Land East of J11, M40, Banbury Supplementary Environmental Information Volume 2: Appendices

Land East of Junction 11 of the M40, Banbury

Transport Assessment Addendum

26th October 2022
SJT/RT/23457-06f Transport Assessment Addendum

Based upon the ORDNANCE SURVEY MAPS with the permission of THE CONTROLLER OF HER MAJESTY'S STATIONERY OFFICE,
 © Crown Copyright AL 100030412
 © David Tucker Associates

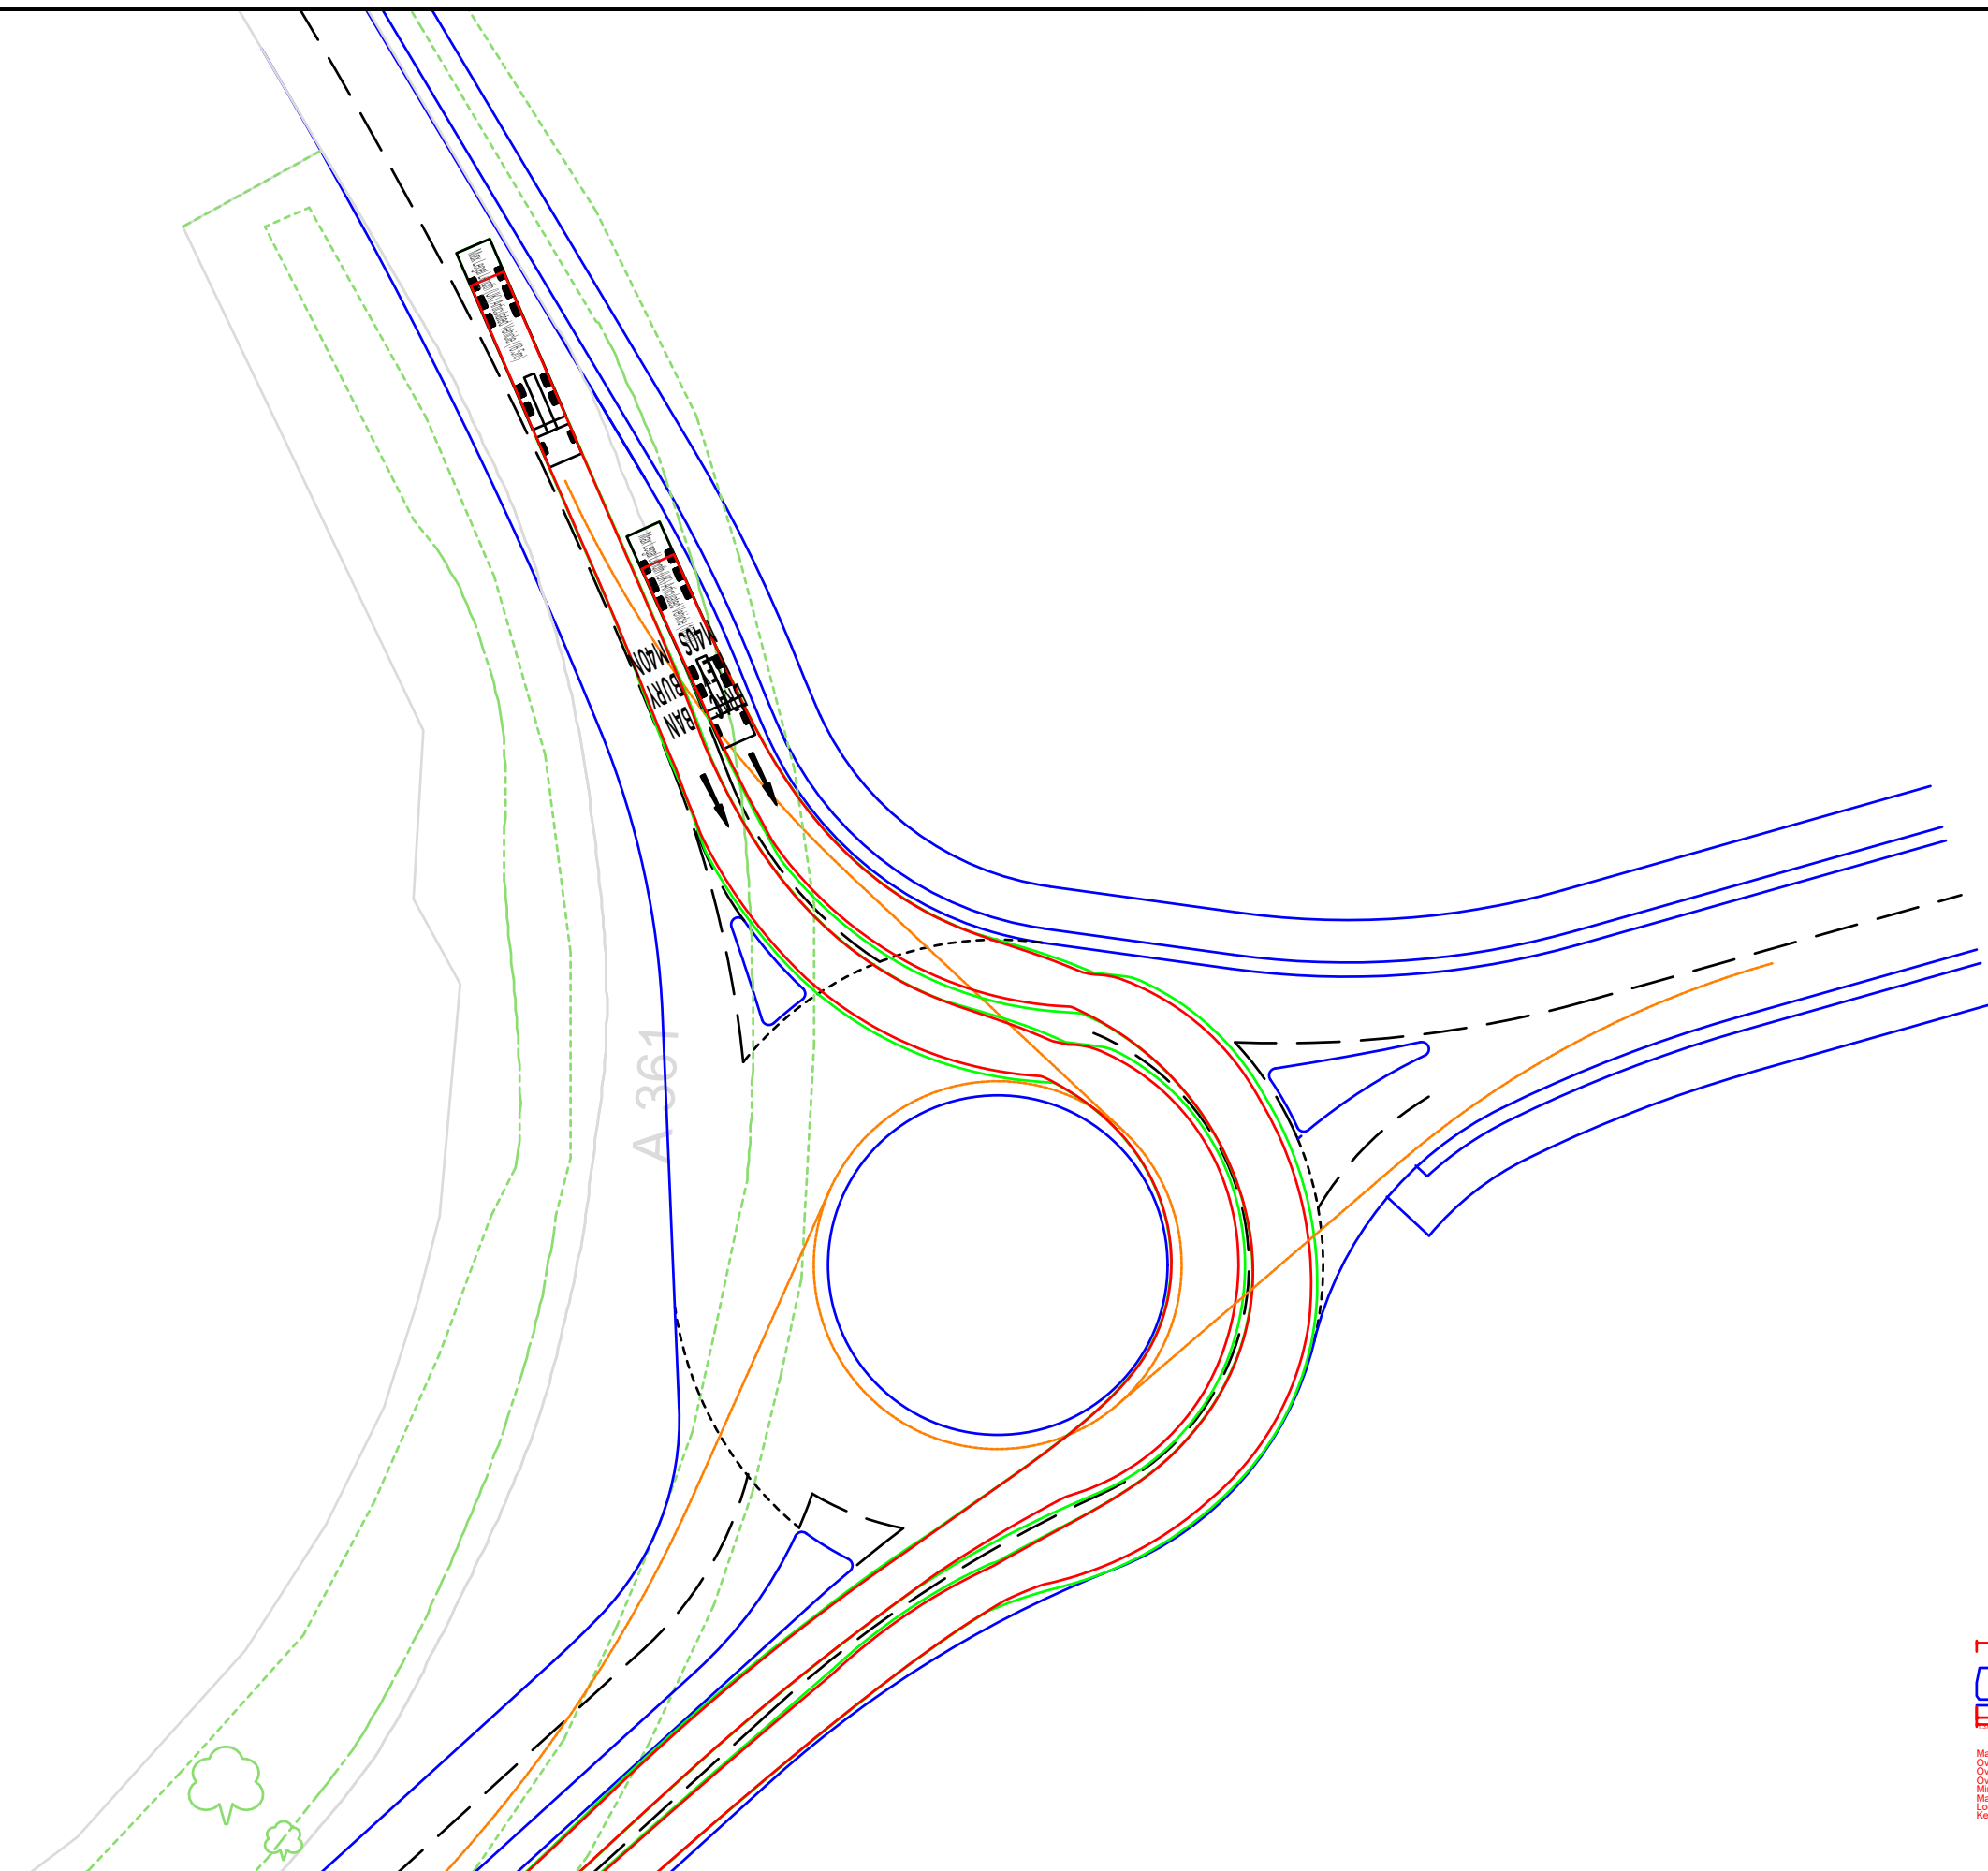
length of queues and the resulting congestion in the area. It has not been demonstrated in a VISSIM simulation that widening the A361 to two lanes between the proposed and existing roundabouts, and increasing the gyratory entry flare to three lanes, is sufficient to mitigate for the effect of the additional vehicles. Also, it has not been demonstrated that these proposed highway modifications are feasible, considering the level differences between the carriageway and the surrounding land.

demonstrated in a VISSIM simulation that widening the A361 to two lanes between the proposed and existing roundabouts, and increasing the gyratory entry flare to three lanes, is sufficient to mitigate for the effect of the additional vehicles. Also, it has not been demonstrated that these proposed highway modifications are feasible, considering the level differences between the carriageway and the surrounding land. Indicative cross-sections and the relation to the highway boundary should be included.

- 1.6 Significant improvements are proposed to improve the operation of the M40 Junction 11 gyratory. To ensure that the site access will operate efficiently the increase in performance addresses significant queueing forecast on the A361 arm. The applicant agrees to the obligation to deliver these improvements via a S278 agreement. The proposed plans can be seen in **Drawing 23457-06a-02-GA** with the associated vehicle tracking in **Drawing 23457-06a-04-TRK**.

- 9.12 The proposed mitigation will provide an additional entry lane and significantly more stacking space. As can be seen in **Table 5** the performance of the junction is significantly improved and the potential for queuing has significantly reduced relative to the baseline. The mitigation therefore more than offsets the development demand. With respect to an interaction between the junctions, this is unlikely to occur in practice as the layout of the site access provides significant spare capacity to maximise its resilience.

- 9.13 The widening of link between the site access and the adjacent gyratory requires additional land only from within the site boundary and there is no constraint to the ability to provide the required side slopes.
- 9.14 To further improve the performance of the A361 arm, the entry can be signalised. This has been modelled on the basis of two entry lanes (rather than the three that would
